Program Bulletin

CUSTOMER SATISFACTION PROGRAM

SUBJECT: Exterior Door Handle Binds or Sticks

MODELS: 2015 Chevrolet Impala

Door outside handle bracket (1) shown with clips (2), mounted inside door.

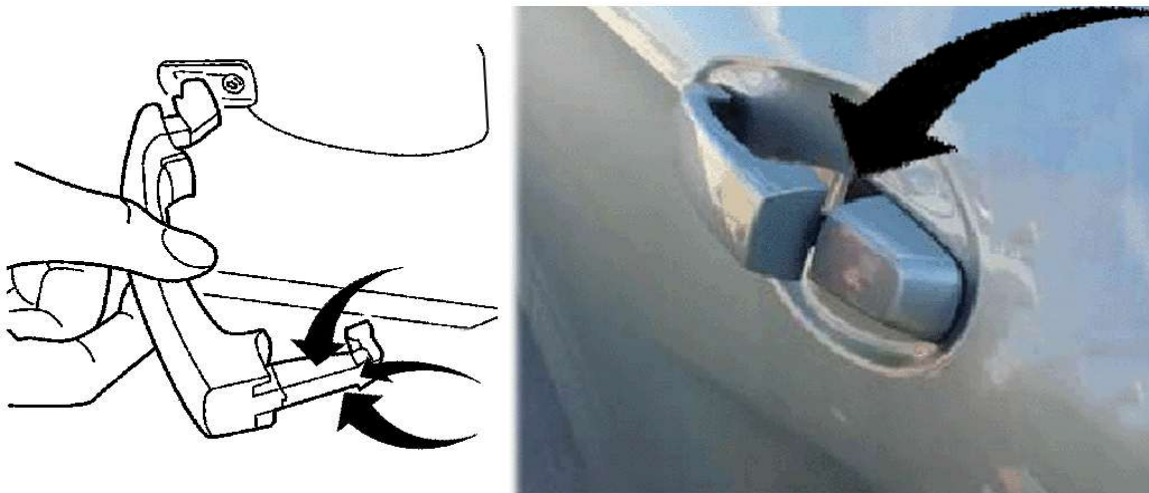
Note: Door latch does not have to be removed to replace the bracket in either front or rear replacement procedures. Unclip latch cables during removal.

- 3. Replace door handle bracket on binding or sticking handle. Refer to *Front Side Door Outside Handle Bracket Replacement* in SI. For replacement of rear door handle bracket, refer to *Rear Side Door Outside Handle Bracket Replacement* in SI.
